POSITION

Subject: Response to the Elia consultation on the general requirements for RFG, DCC, HVDC and storage
Date: 23 April 2018
Contact: Steven Harlem
Phone: 0032 2 500 85 89
Mail: steven.harlem@febeg.be

This document is the response of the **Belgian Generators' Associations (BGA): this is an *ad hoc* cooperation of the associations BOP, COGEN, EDORA, FEBEG and ODE.**

PROPOSAL FOR NC RFG REQUIREMENTS OF GENERAL APPLICATION

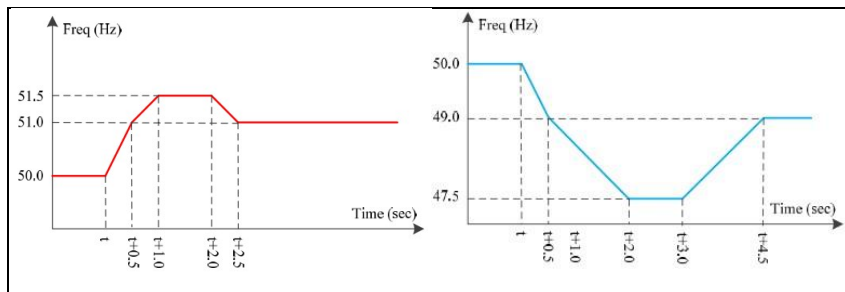
Commented [A7]: Is it possible to combine these time windows? In other words if the frequency stays above 47,5Hz does one needs to stay connected for 30 or 60 minutes. For us this should be 30minutes and thus summarized to 47,5Hz – 49 Hz. As problems will occur with connected engines and generators (increasing flux leading to heating of the stator).

Commented [A8]: How can frequency be local?

Figure 6: Clarification of the concept of net and gross measurement.

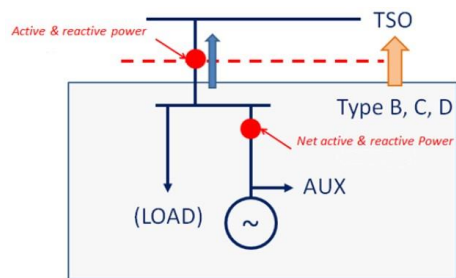
Commented [A28]: The connection point belongs to TSO/DSO. The PGM cannot be responsible for those measurements. Why to mention this?

Commented [A29]: This drawing is too simplistic. What about step-up transformers?

Figure 7: Capability curve for SPGM type B

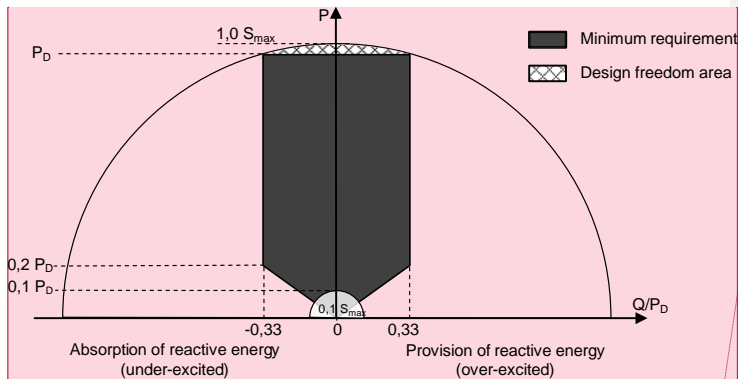
Commented [A34]: The limitations of the AVR limiter/underexcitation protection (or Q32) are not indicated on the most P/Q-capacity diagrams of generators. Those protections add additional limitations on the P/Q capacity of the generation and shall be taken into account for the extended capabilities.

Figure 9: FRT requirement for SPGM type B and C

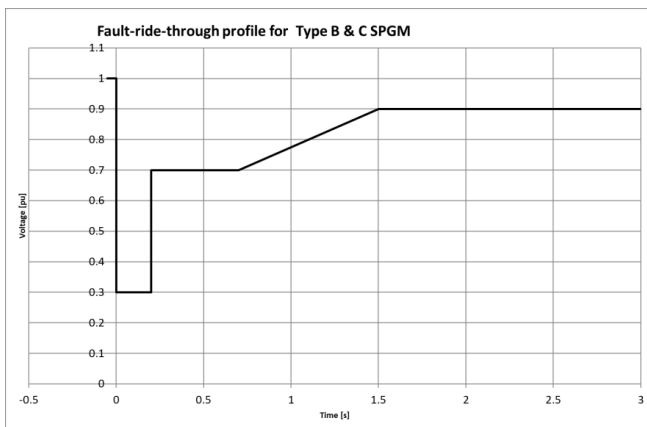
Commented [A33]: Figure is drafted for terminals of alternator. Not at the HV side of the step up transformer.

Commented [A38]: Should be measured at the alternator, not the HV side of the transfo.

Figure 10: FRT requirement for PPM type B and C

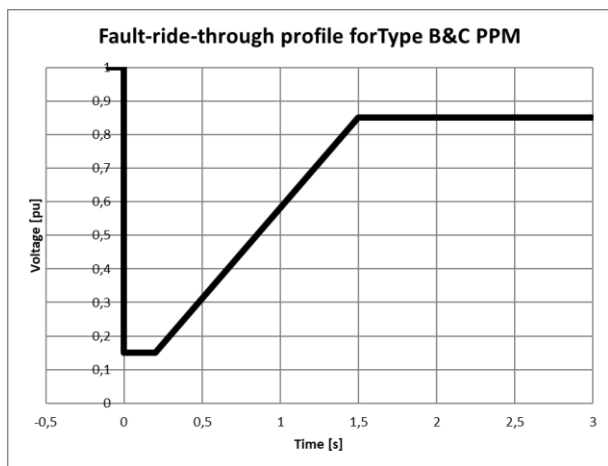
Commented [A42]: Value of 1 pu is missing.

Figure 9-6: Reactive current injection

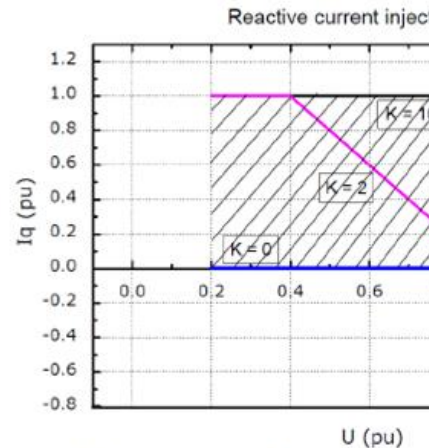
Commented [A52]: We do not inject a zero sequence. I do not see how this is physically possible through a transformer! In Germany the grid codes even forbids to inject a zero sequence.
Proposal: delete the word "zero-sequence."

Figure 15 Active power response capability

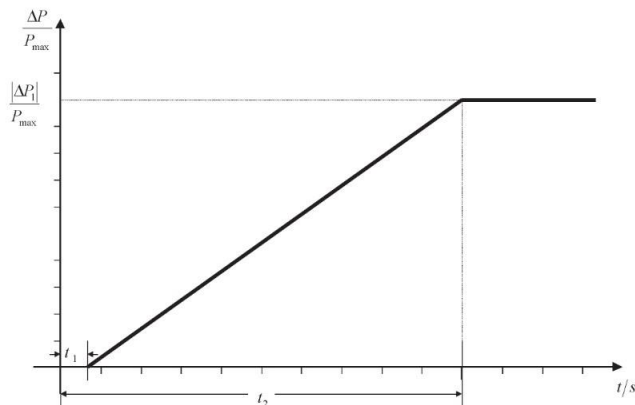
Commented [A63]: We prefer that the current values are maintained.

Figure 16 : Principle of the voltage and reactive power control

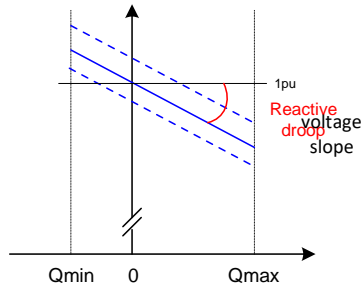
Commented [A77]: This is a value from the old law and has to be modified in coherence with the current requirements for reactive power

Figure 17: Capability curve for SPGM type C and D.

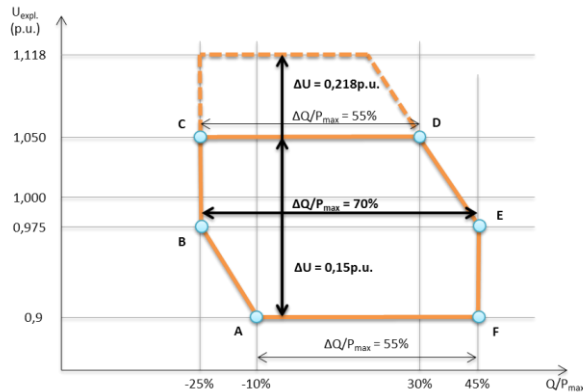
Commented [A78]: For consistency best to change to: *the required reactive capabilities should be met at the HV side of the step up transformer if existing; otherwise it should be met at the alternator terminals*

Commented [A79]: RfG (figure 7) imposes a max. value of 1.1 pu. To correct.

Commented [A80]: Generators may have high restriction for absorbing Q with low voltage (core end heating from axial flux). The limitation of the stator current is in this case proportional to the square of the terminal voltage.

Figure 18: Reactive power capability for a Type C and D PPM.

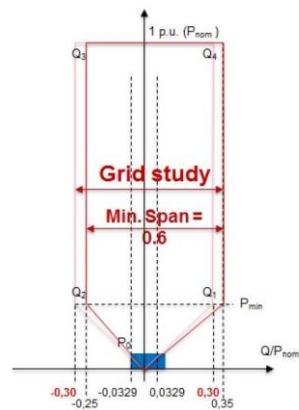
Commented [A81]: Change to: *the required reactive capabilities should be met at the HV side of the step up transformer if existing; otherwise it should be met at the alternator terminals*

Commented [A82]: Not according to RfG figure 8.

Figure 1 Example of Storage Park Module grid connection

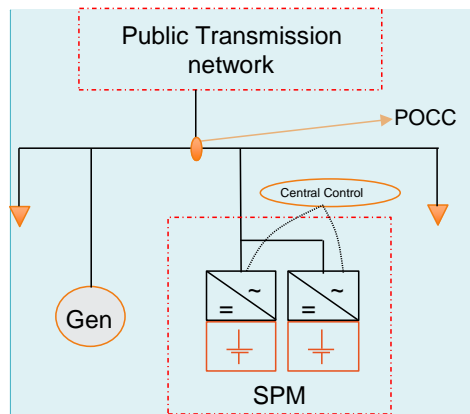
Commented [A5]: POCC → Connection point

Figure 3: Capability curve for SPM type B

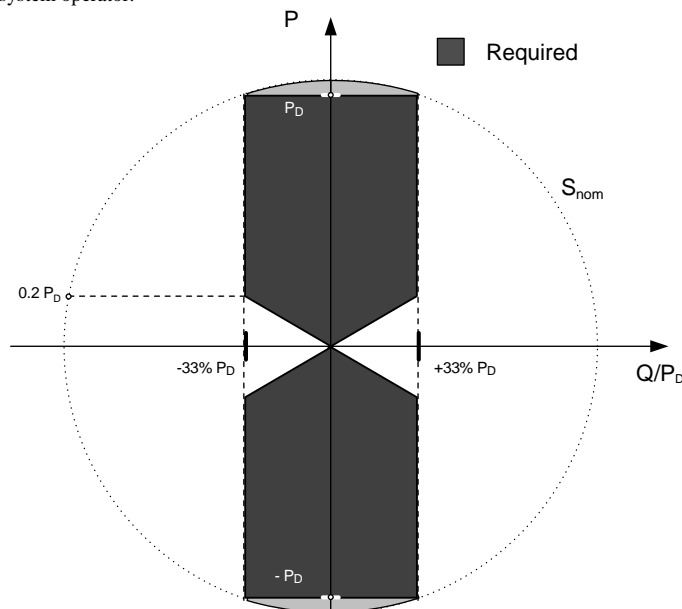
Commented [A35]: Investeerder worden naar hogere uitgaven geduwd. Welke vergoeding voorziet Elia om de full capability aan te bieden?

Figure 6: Reactive power capability for a Type C and D SPM.

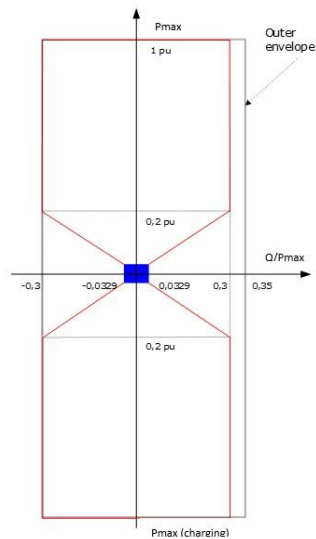
Commented [A45]: Dimensions on the P axis not specified.

Figure 7 U-Q/Pmax profile for a type C and D SPM (dashed for nominal voltages above 300kV).

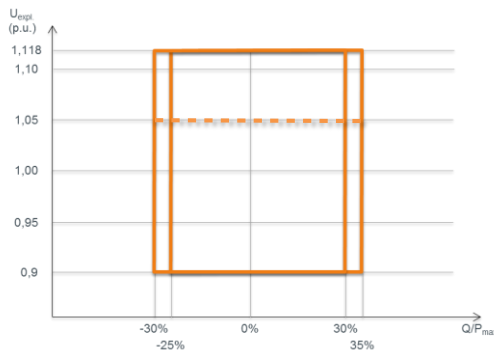
Article 6.3, figure 7:

Maximum voltage should be equal to 1.1 p.u and not 1.18 p.u.

Commented [A46]: Max. voltage should be 1.1 pu and not 1.18 pu.
